Measurement of projections at recessed balconies

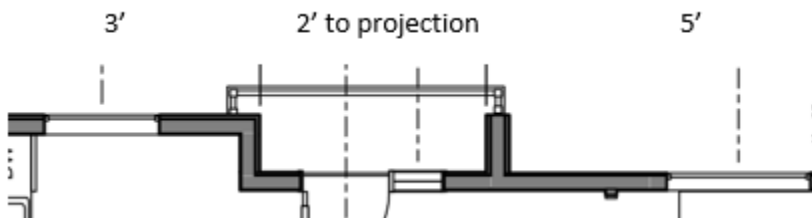
The balconies are about 3' deep, including 2' which are recessed into the building and about 1' projected outward.

The distance from the lot line to the various elements are shown on this plan view:

For purposes of applying Table 705.2, the applicant would like to use the 3' fire separation distance.

When a balcony is recessed into the mass of the building, from what segment of the exterior wall would the fire separation distance be measured for purposes of determining the minimum allowed distance of a projection from a lot line?

Or, do the balconies project to 2' from the lot line at an exterior wall 5' from the lot line, in violation of Table 705.2?

Where the exterior wall does not follow the same plane and is segmented, the FSD of exterior wall for each segment will be considered individually. In other words, if a projection is allowed in one segment of the exterior wall, you cannot apply that same FSD across the entire side of the building to increase the size of a balcony at an exterior wall in a different segment.

At the balcony, the fire separation distance shall be measured from the exterior wall at the back of the balcony (5' in this case).

From the Code and Commentary:

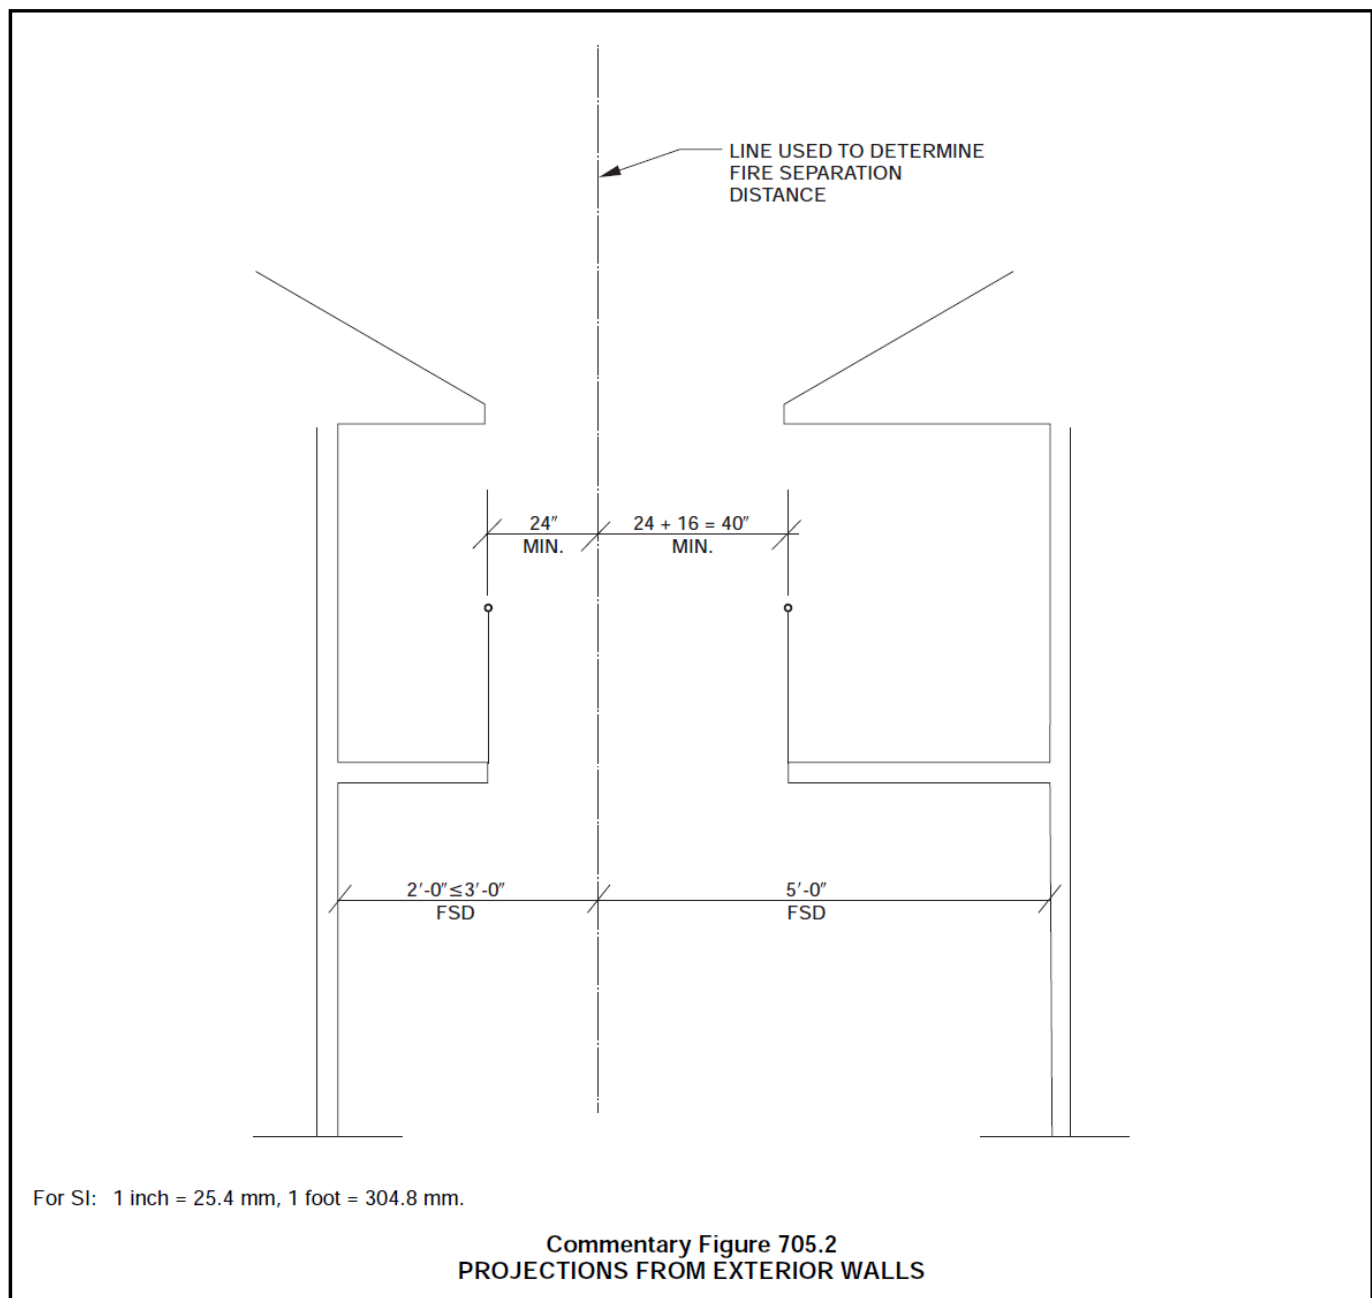
Per the Code and Commentary: “The first column in Table 705.2 is Fire Separation Distance (FSD) and is measured from the lot line or assumed lot line to the exterior wall...”
